# Access Compliance Report

## Public Rights-of-Way

Intersection ID: 2858	Main Street: FOGGY_MEADOW_RD	Cross Street: DEARVIEW_LN	Location: SW
ADA ID: 193E608849B8	Ramp Type: Perp	Initial Pass/Fail: Fail	Overall Compliance: No
		Severity Score: 12.5

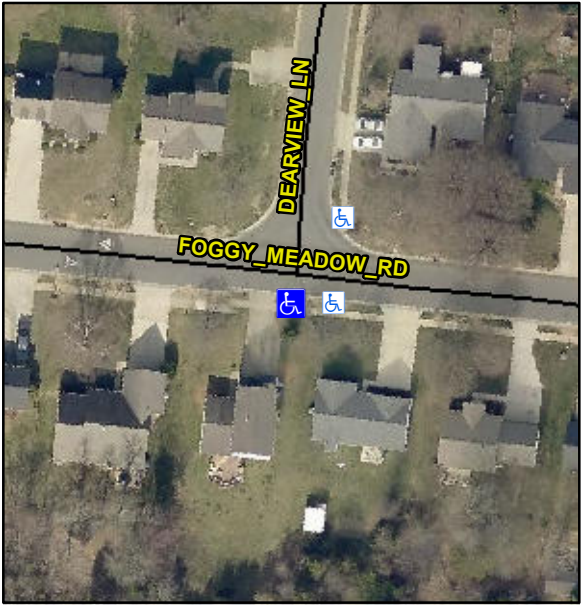
Codes/Mitigation Info/Possible Solution			Field Measurements/Component Compliance		
	Possible Solutions:		<b>Compliance</b>	<b>Description</b>	<b>Data</b>
	<b>Remove &amp; Replace Entire Ramp.</b>		<b>No</b>	Ramp Length (in)	<b>47.0</b>
			<b>Yes</b>	Ramp Width (in)	<b>48.0</b>
			<b>N/A</b>	Flare Type LT	<b>N/A</b>
			<b>N/A</b>	Flare Slope LT (%)	<b>N/A</b>
			<b>N/A</b>	Flare Traversable LT?	<b>N/A</b>
			<b>N/A</b>	Landing Length (in)	<b>N/A</b>
			<b>N/A</b>	Landing Width (in)	<b>N/A</b>
			<b>N/A</b>	Landing Slope (%)	<b>N/A</b>
			<b>N/A</b>	Landing X Slope (%)	<b>N/A</b>
<p>Surveyor Notes:</p> <p><b>N/A</b></p> <p>PROW/ADA:</p> <p><b>Not Found, R304.2.2</b></p>			<b>N/A</b>	Flare Type RT	<b>N/A</b>
			<b>N/A</b>	Flare Slope RT (%)	<b>N/A</b>
			<b>N/A</b>	Flare Traversable RT?	<b>N/A</b>
			<b>N/A</b>	DWS Provided?	<b>N/A</b>
			<b>N/A</b>	DWS Contrast?	<b>N/A</b>
			<b>N/A</b>	DWS Length (in)	<b>N/A</b>

<b>N/A</b>	DWS Full Width?	<b>N/A</b>
			<b>N/A</b>	DWS Offset (in)	<b>N/A</b>
			<b>N/A</b>	Gutter Ponding?	<b>N/A</b>
			<b>N/A</b>	Gutter Lip Ht (in)	<b>N/A</b>
			<b>No</b>	Painted X Walk1?	<b>N/A</b>
			<b>To NE</b>	X Walk 2 Direction	<b>N/A</b>
			<b>N/A</b>	X Walk 2 Width (in)	<b>N/A</b>
			<b>4.6</b>	X Walk 2 Slope (%)	<b>N/A</b>
			<b>4.0</b>	X Walk 2 X Slope (%)	<b>N/A</b>
			<b>N/A</b>	Ramp inside XWalk1?	<b>N/A</b>
			<b>N/A</b>	Ramp inside XWalk2?	<b>N/A</b>
			<b>N/A</b>	Clear Space?	<b>N/A</b>
			<b>N/A</b>	Clear Space to XWalk (in)	<b>N/A</b>
			<b>N/A</b>	Storm Grate/Utility Hazard?	<b>N/A</b>
			<b>N/A</b>	Storm Grate/Utility Type	<b>N/A</b>
			<b>Yes</b>	Surface Condition? (G/P)	<b>Good</b>
Total Cost:		\$ 1850.00
